PG&E Letter DCL-18-064

Diablo Canyon Units 1 and 2
Docket No. 50-275, OL-DPR-80
Docket No. 50-323, OL-DPR-82
<u>License Amendment Request 18-01</u>
Request to Revise Emergency Plan Response Organization Staffing and Augmentation

License Amendment Request 18-01 Request to Revise Emergency Plan Response Organization Staffing and Augmentation

5.205.21 FIGURE 5-2, TSC ORGANIZATION

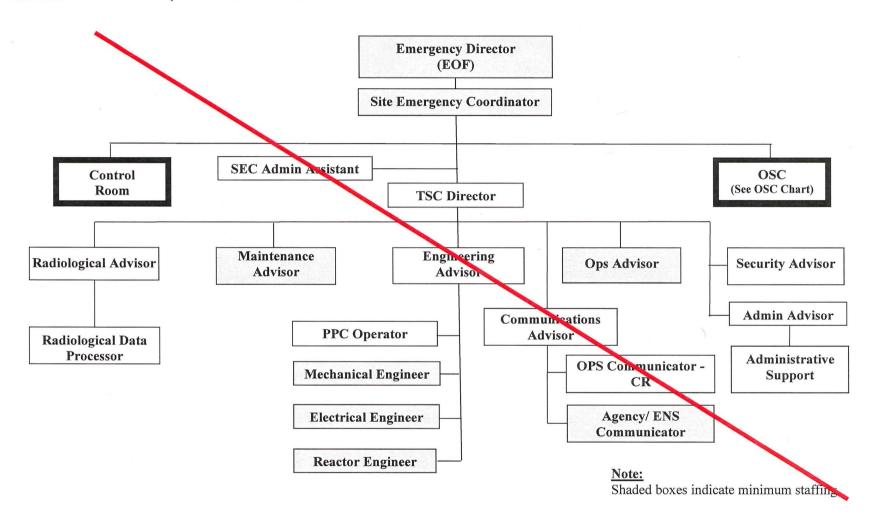
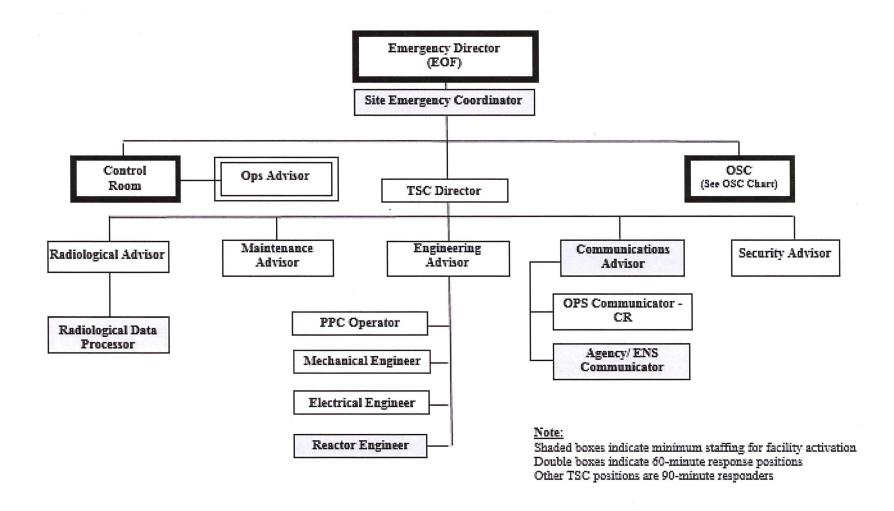
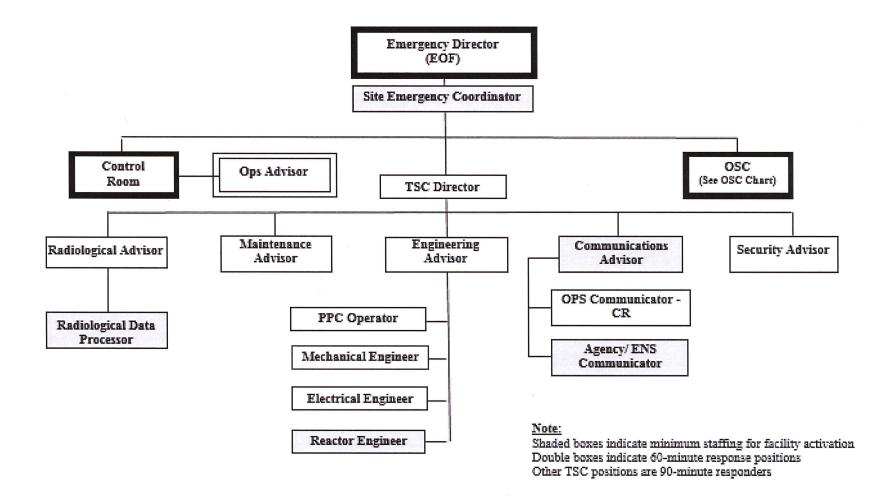
- u. Section 5.18, "Table 5-1B," is deleted and combined into new Table 5-1.
- v. Section 5.20, "Figure 5-2, TSC Organization," is revised to reflect new minimum staffing for facility activation.

5.215.22 FIGURE 5-3, OSC ORGANIZATION

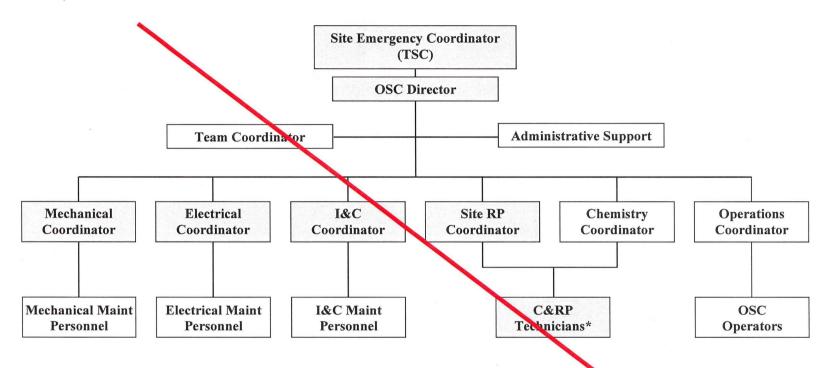
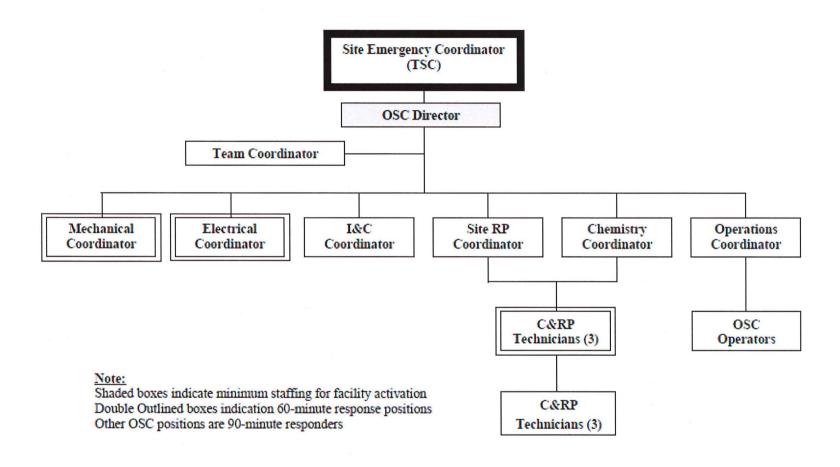
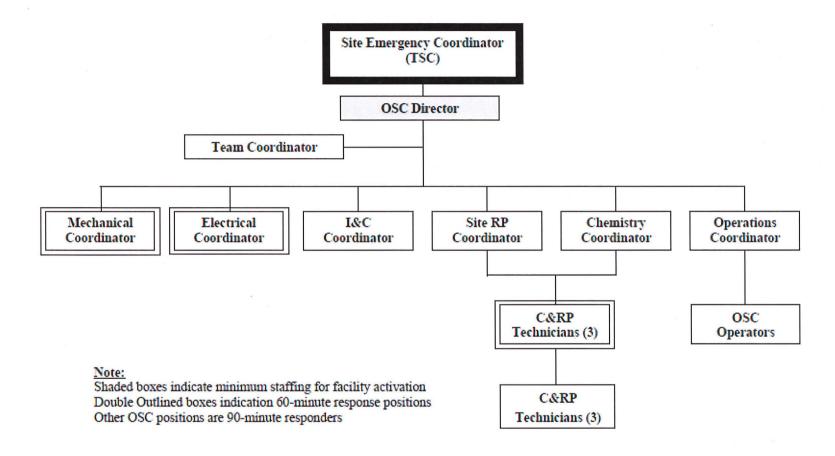
- w. Section 5.21, "Figure 5-3, OSC Organization," is revised to reflect new minimum staffing for facility activation as well as delineate 60 and 90-minute response positions.

- * 8 C&RP Technicians:
 - 4 In-plant protective actions
 - 2 In-plant surveys
 - 2 FMT members

5.225.23 FIGURE 5-4, EOF ORGANIZATION

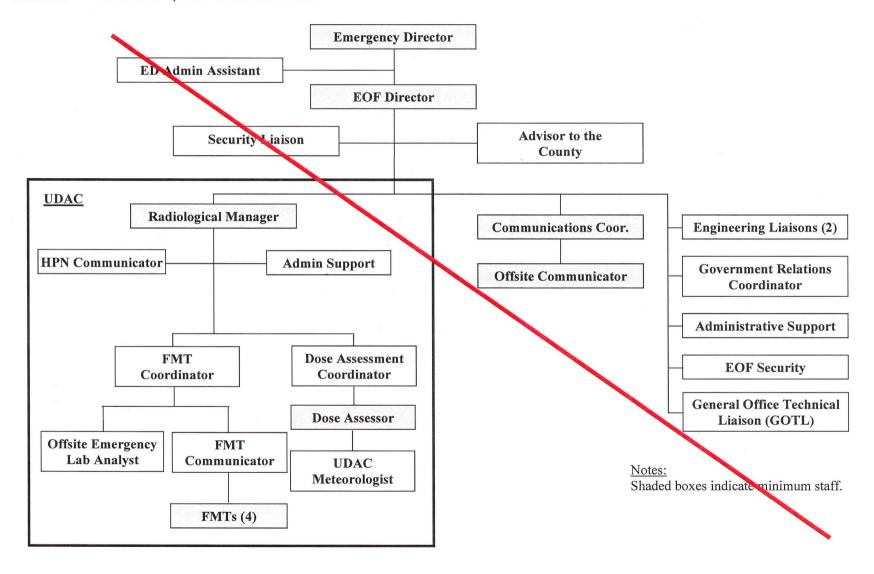
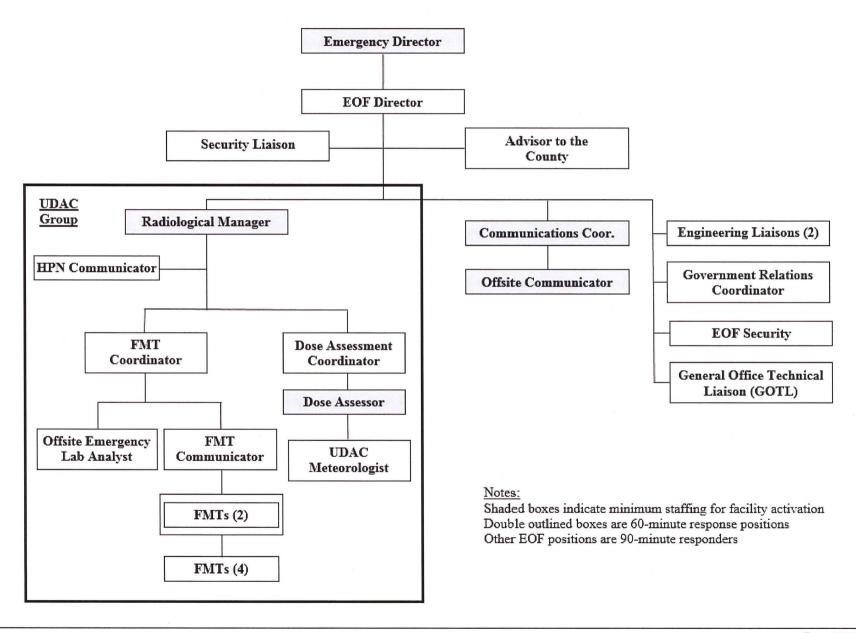
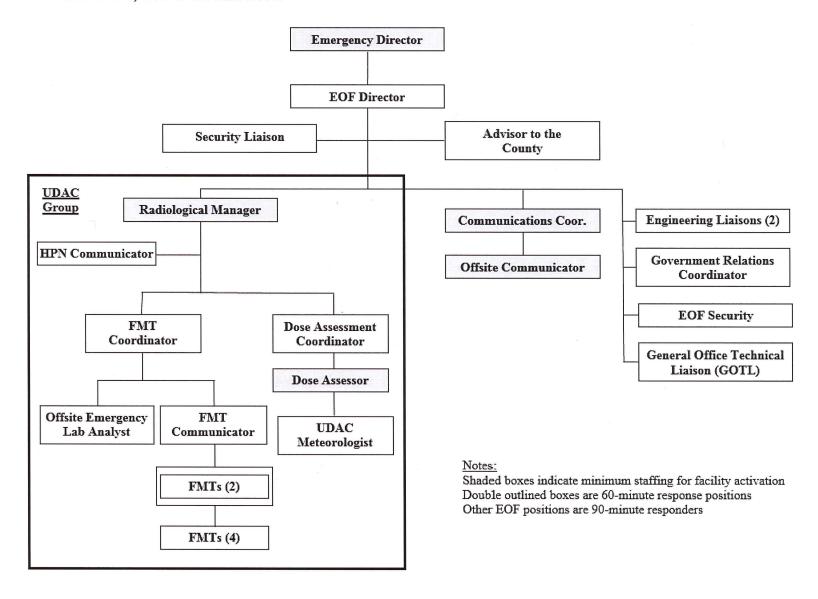
- x. Section 5.22, "Figure 5-4, EOF Organization," is revised to reflect new minimum staffing for facility activation and reflect reporting of the

5.235.24 FIGURE 5-5, JIC ORGANIZATION

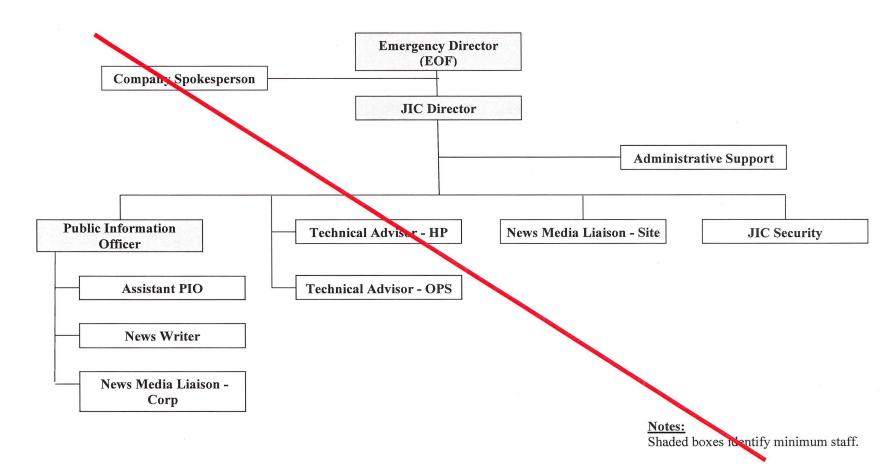
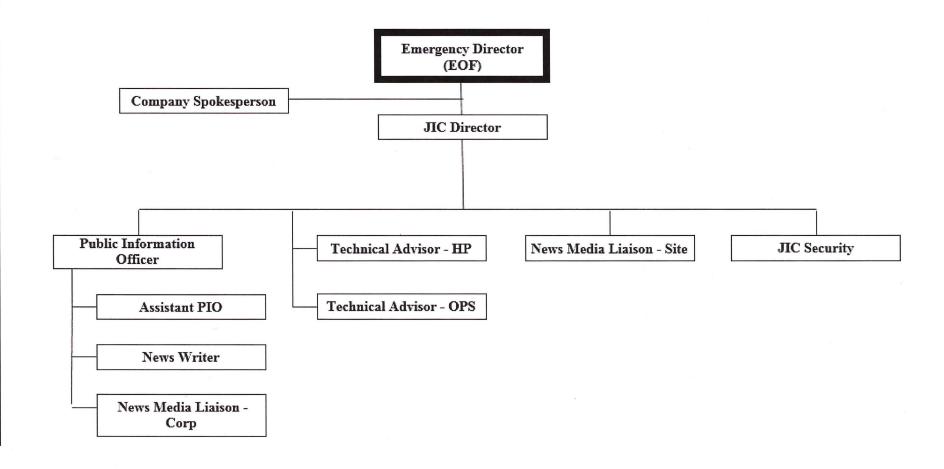
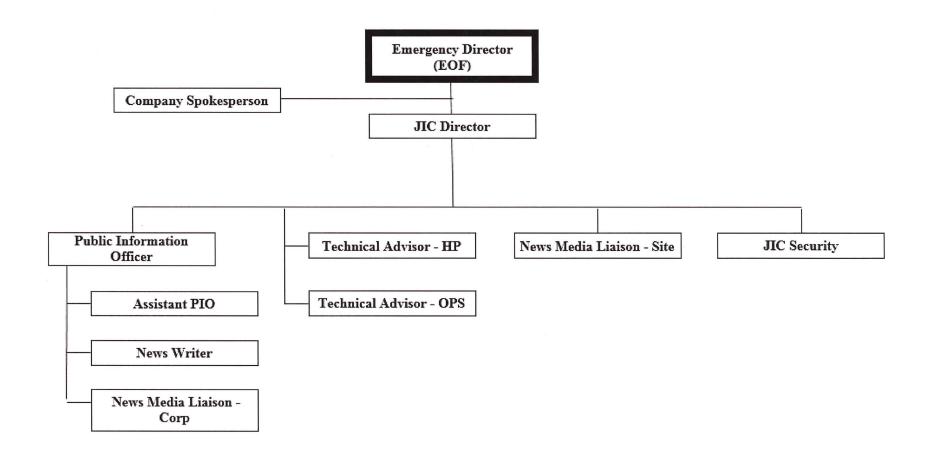
- y. Section 5.23, "Figure 5-5, JIC Organization," is revised to reflect application of facility 'staffing' and removal of references to 'activation'.
- z. Section 6.1.2, "Emergency Response Facility Activation," is revised to reflect use of terms 'staffed' and 'activated' as well as timeframe for emergency response facility activation requirements.
